AMENDMENTS TO THE DRAWINGS

Attachment: Replacement Sheet
Annotated Sheet Showing Changes

FIG. 3A

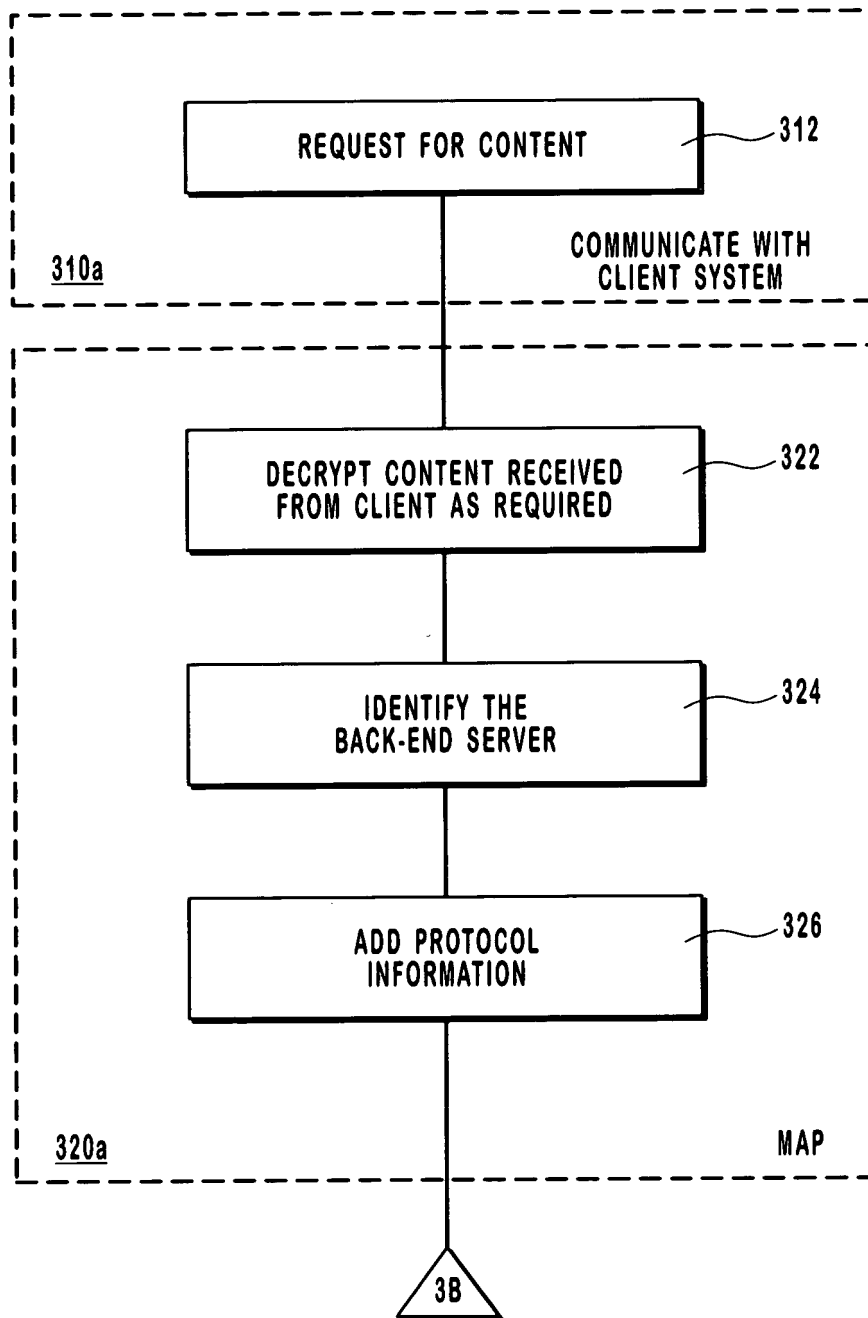
The attached sheets of drawings include changes to Figure 3A. In particular, the amendments to the drawings include changing the text of referenced boxes 324 and 326 to correspond with the text provided in the specification (p. 21, ll. 1-2). Even more particularly, the text of box 324 has been amended to recite "Identify the Back-End Server" and the text of box 326 has been amended to recite "Add Protocol Information."
